Re: Variance Application

Requested Deviation from Lot Size Req. and Side of Lot Setbacks

CONFIRMATION OF PRE-FILE

SUBJECT: 1422 Brewer Road

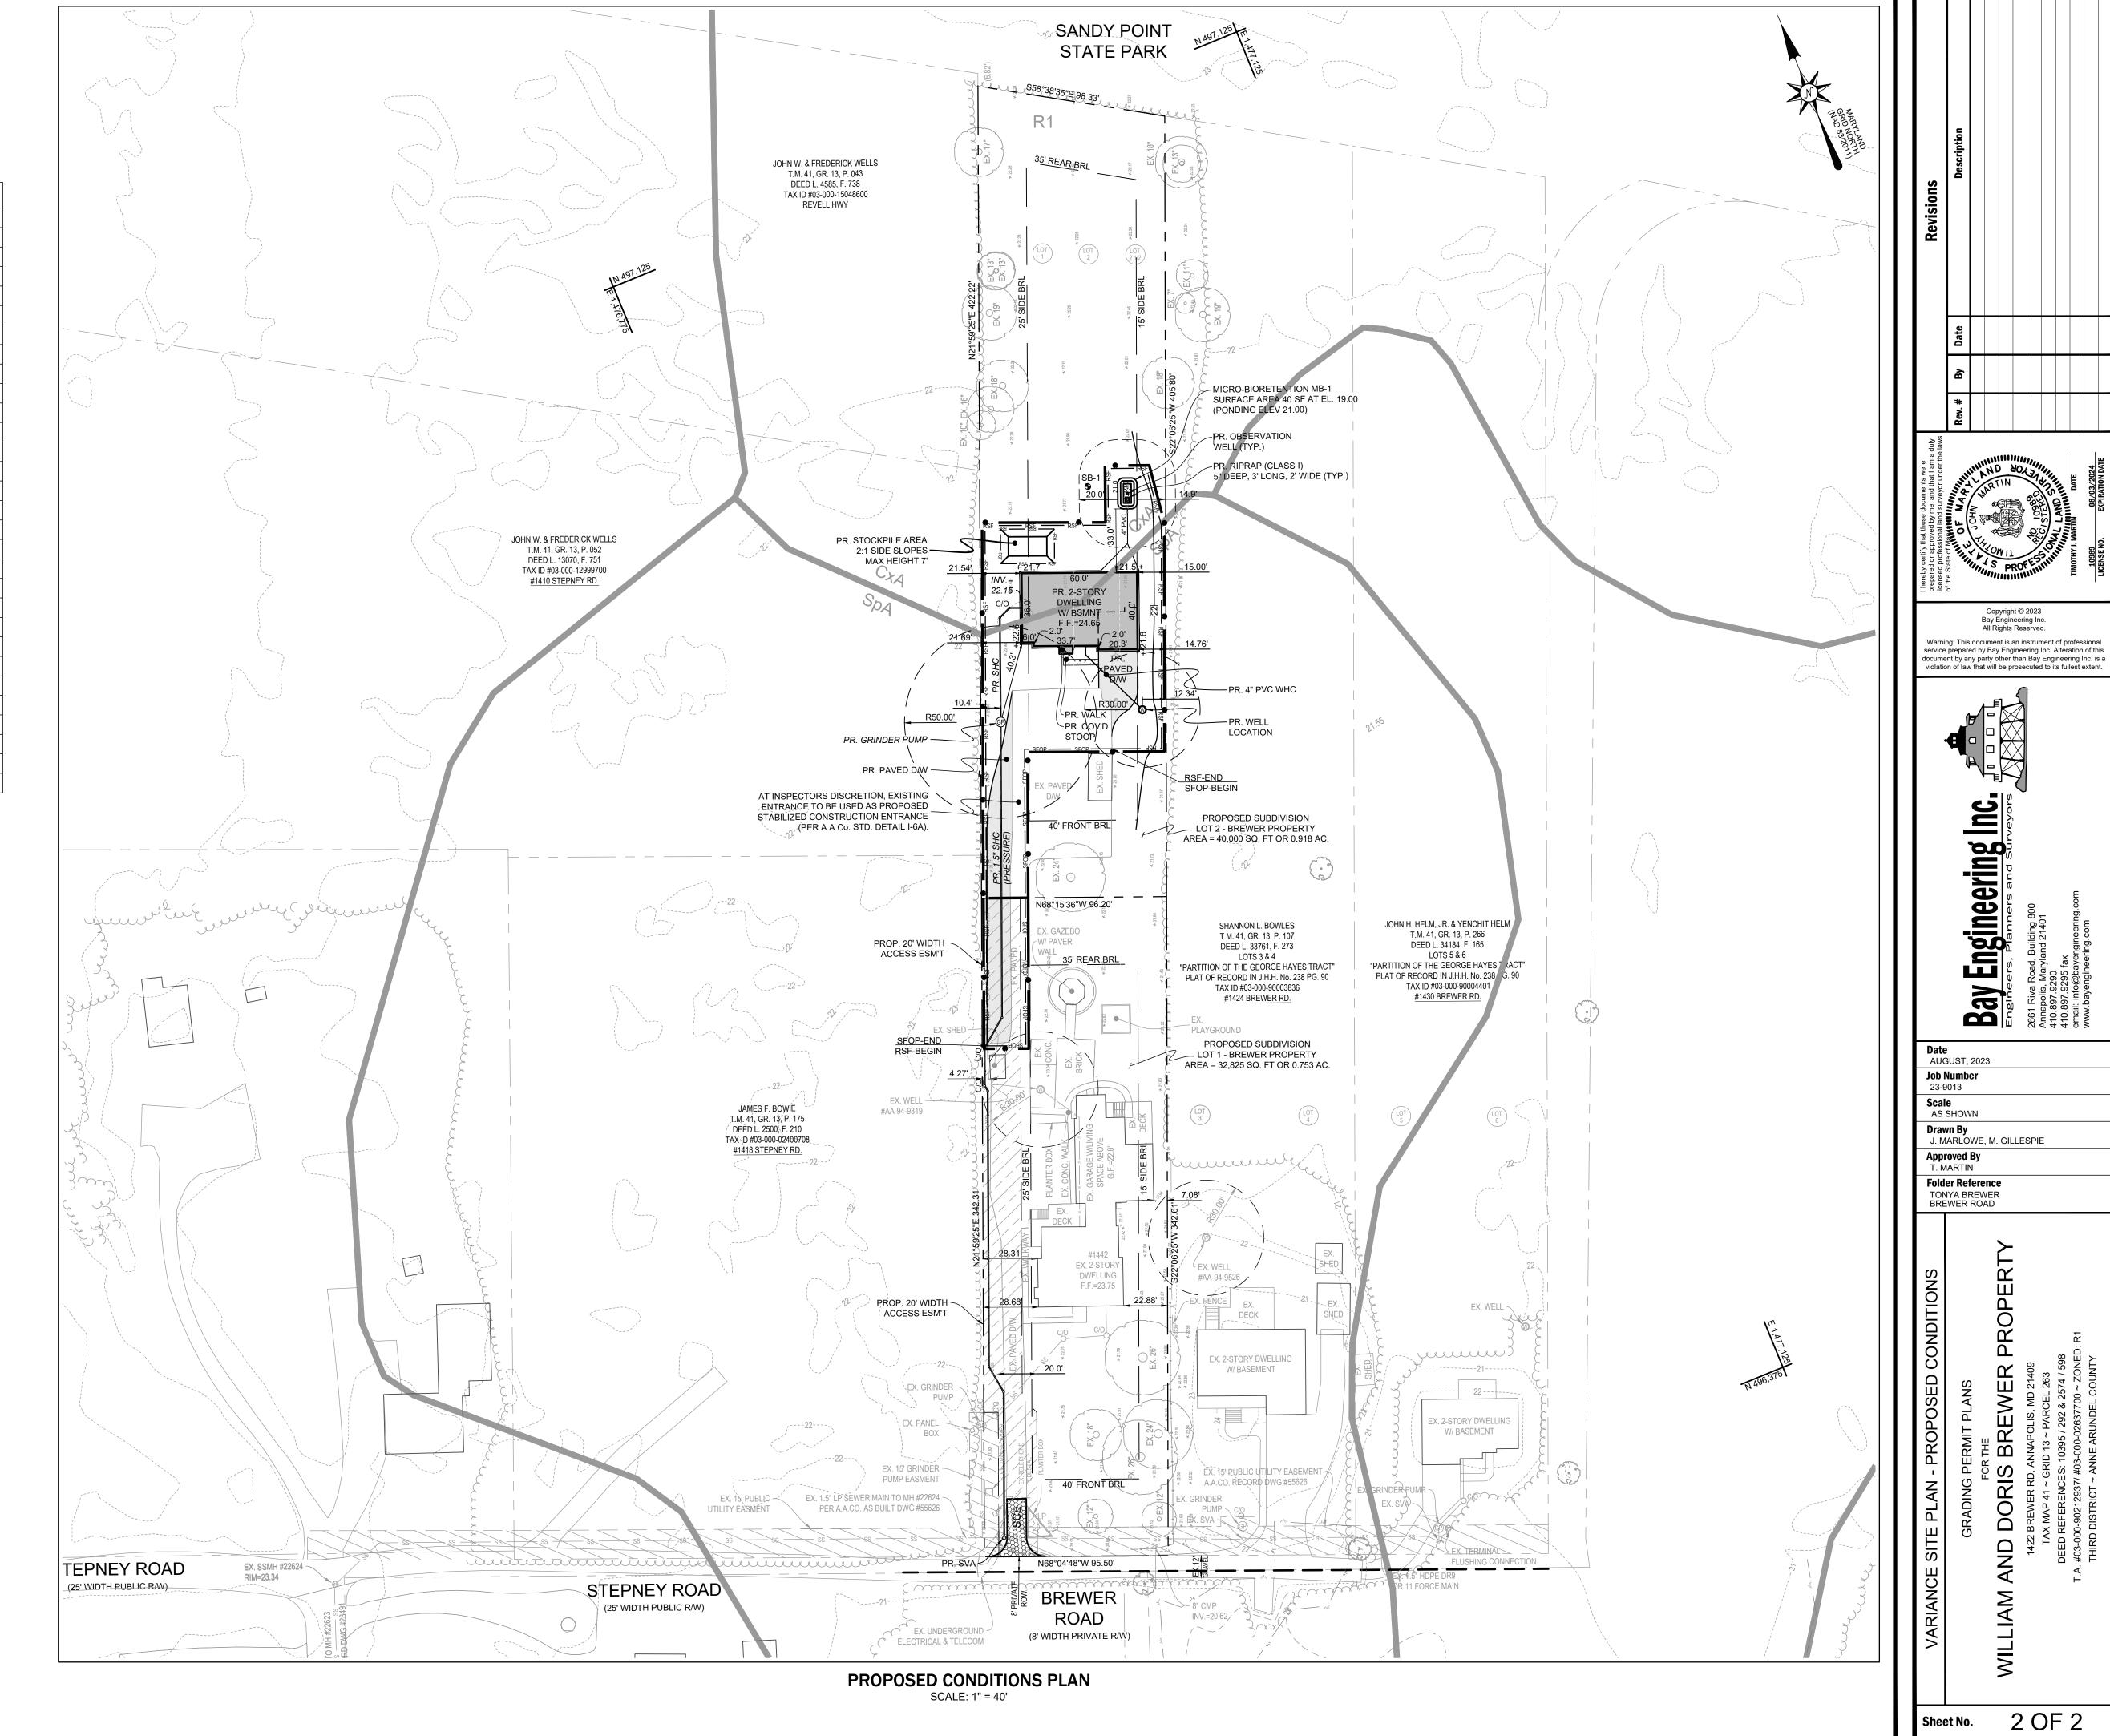
1- SWM must meet ESD to the MEP based on the overall site. Based on COMAR criteria, the site is defined as continuous parcels that are owned by the same entity or being considered as part of a development plan. The SWM report, which will be required to approve the new proposed lot reconfiguration, needs to provide site fingerprinting and explore conservation first, then minimization of imperviousness, then non-structural practices (alternative surfaces, disconnections, and sheet flow to the protected area". Reliance on micro-practices changes the sheet flow pattern and places a maintenance burden on future homeowners and should be avoided to the extent practical.

- Site plan: Indicate the height of the proposed dwelling on the site plan in the area of the dwelling footprint.
- There is ample room on the proposed Lot 2 to locate a dwelling in compliance with the R1 District bulk regulations without requiring a variance to setbacks.

- The pre-file comments were not addressed. A SWM concept plan that addresses ESD to the MEP through site fingerprinting and reliance on conservation or nonstructural SWM practices for the entire site was not performed to show that the subdivision of the site can be achieved without reliance on micro-structural practices.

- A minor subdivision application is required for subdividing this lot. A minor subdivision would require frontage improvements/ROW dedication.
- This subdivision would create a private road that is in excess of 150 feet in length with no emergency/fire turnaround and does not meet the minimum standards for a private road.

- A low-pressure sewer system serves this property and proposes to discharge into a private low-pressure sewer connection. Capacity has not been verified. Further, if other properties in the area are granted the same variance to increase the density, the current 1.5-inch low-pressure sewer may not be adequate.

Determination: This office cannot recommend approval of the variance until the prefile comment is addressed adequately with the variance application.

Determination: Due to the comments above, this office does not recommend approval of the variance.
